**AMBROSE LAKE**  
 SITE PLAN - R-20 (OSC)

**PETITION NO:** Z-35

**ZONING COMMENTS:**

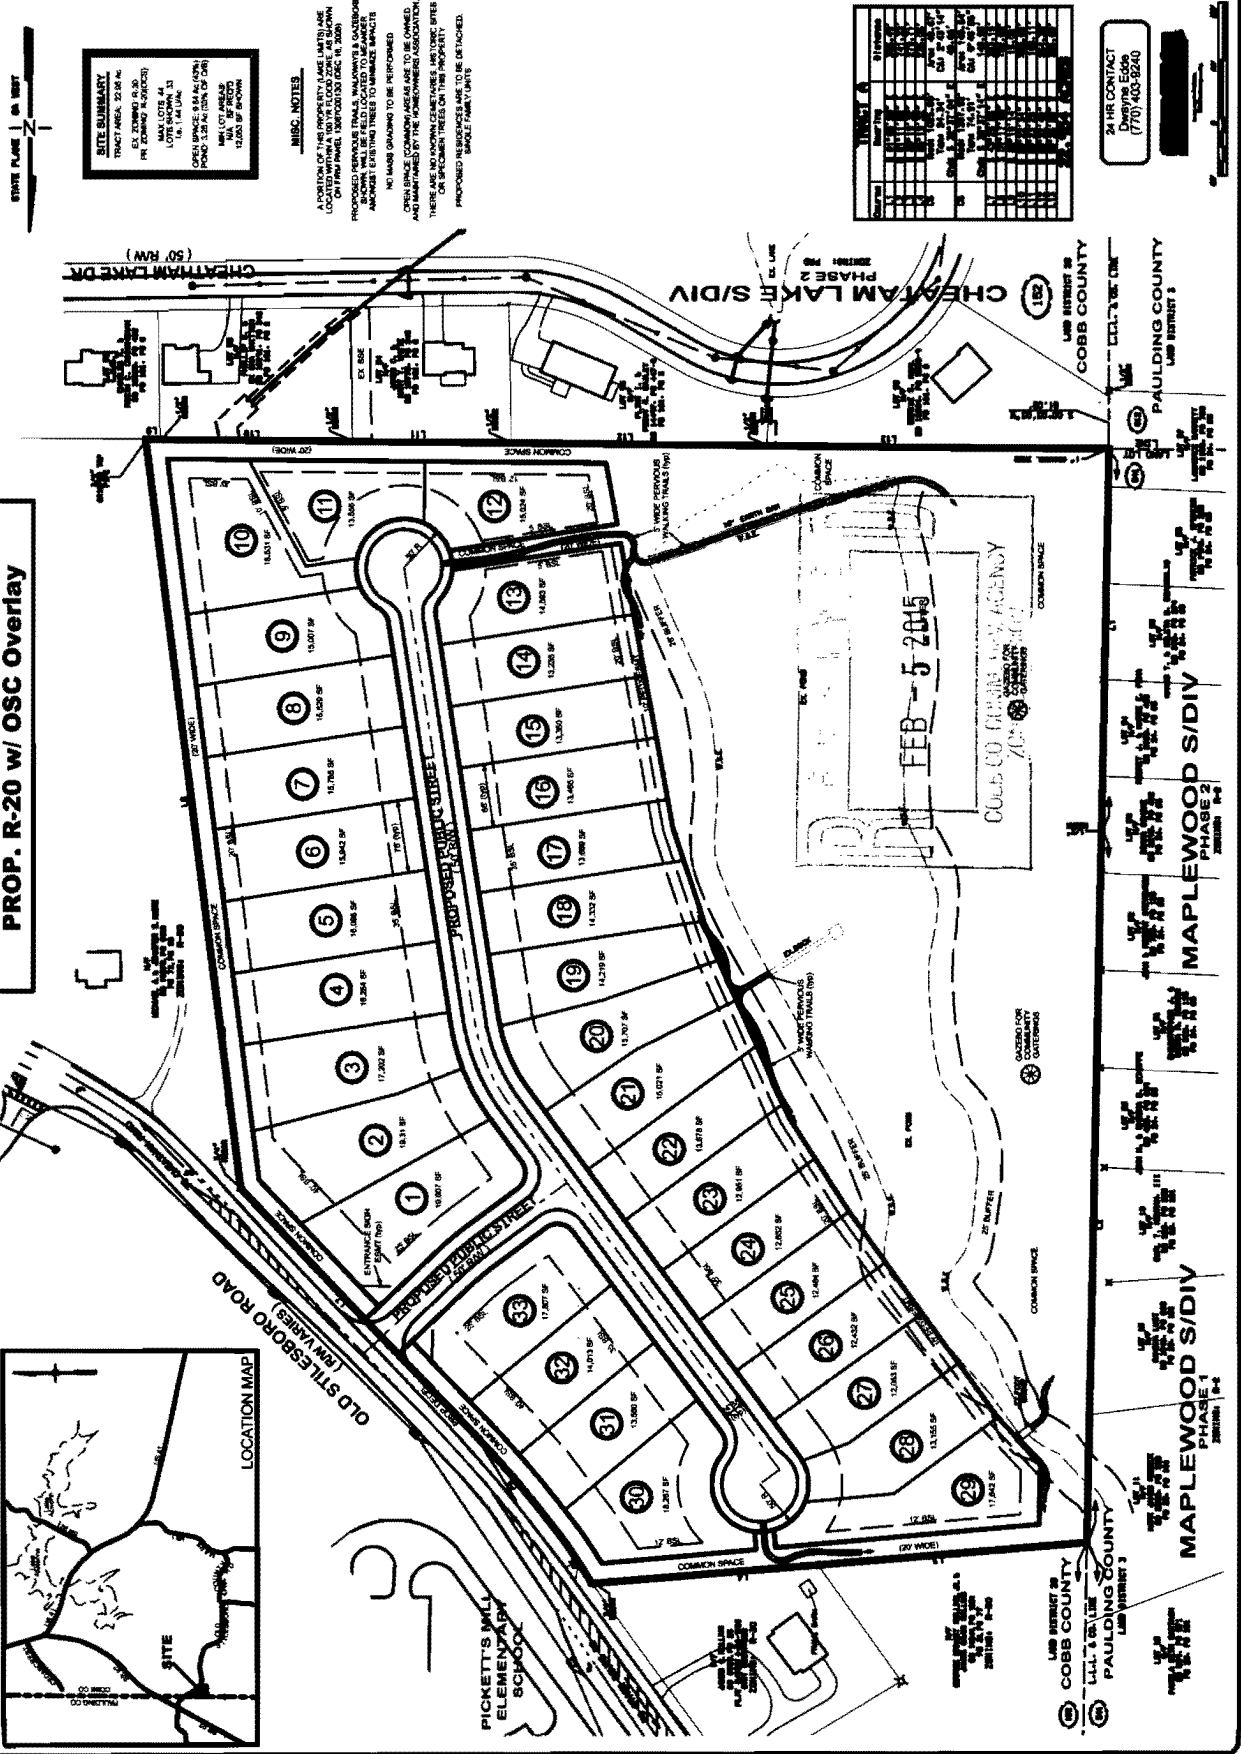
While side setbacks are not indicated for all lots, the OSC code calls for the sum of the side setbacks to equal the total sum of the side setbacks of the underlying zoning district. Therefore, side setbacks should be required at 10 feet on each lot. Also, the OSC code requires rear building setbacks for exterior lots adjacent to existing neighborhoods to be equal to or greater than the rear setbacks for those adjacent lots. Therefore, while the applicant is proposing a rear 20 foot setback on those lots along the eastern perimeter along with a 20 foot wide “common area,” the Code requires a 40 foot rear setback for these lots adjacent to R-30 zoned property with an additional “undisturbed perimeter buffer or other suitable form of privacy barrier” at the rear of these exterior lots. Also, the southern side of the subject property abuts the PRD zoned Cheatham Lakes subdivision and, so, these exterior lots should have a rear 30 foot building setback as well as the same “undisturbed perimeter buffer or other suitable form of privacy barrier.”

1. Applicant’s rezoning proposal is not in conformity with the policy and intent of the Cobb County Comprehensive Plan, which delineates this property to be within the Rural Residential (RR) land use category, having densities range from 0-1 units per acre.
2. Need to list front, rear and side setbacks on site plan.
3. Required stream buffers are considered primary conservation areas within the OSC Ordinance and should be included within the required open space. Please take the portion of lots 25 through 29 that encroach into 25’ buffer out of the buffer area.

- 4. Pedestrian easements shall be a minimum of 15 feet wide and provided when necessary to allow access to open space common areas for all residents. The 10' pedestrian easement should not traverse multiple individual lots. Please include any pedestrian trails/paths within common open space.
- 5. Must have Cobb Department of Transportation approved lighting plan if outdoor lighting (except individual residential lots) is proposed
- 6. A Conservation Easement must be recorded in the mandatory subdivision covenants and with Cobb Superior Court, thereby protecting the "Open Space" from development in perpetuity as owned by the mandatory Home Owners Association. The open space may also be protected via a conservation easement in favor of the county for conservation uses. Application can be acquired and submitted to the Planning Division before final plat approval.

4. The site plan will need to be revised to remove the lots from the County's 50-foot stream buffer.
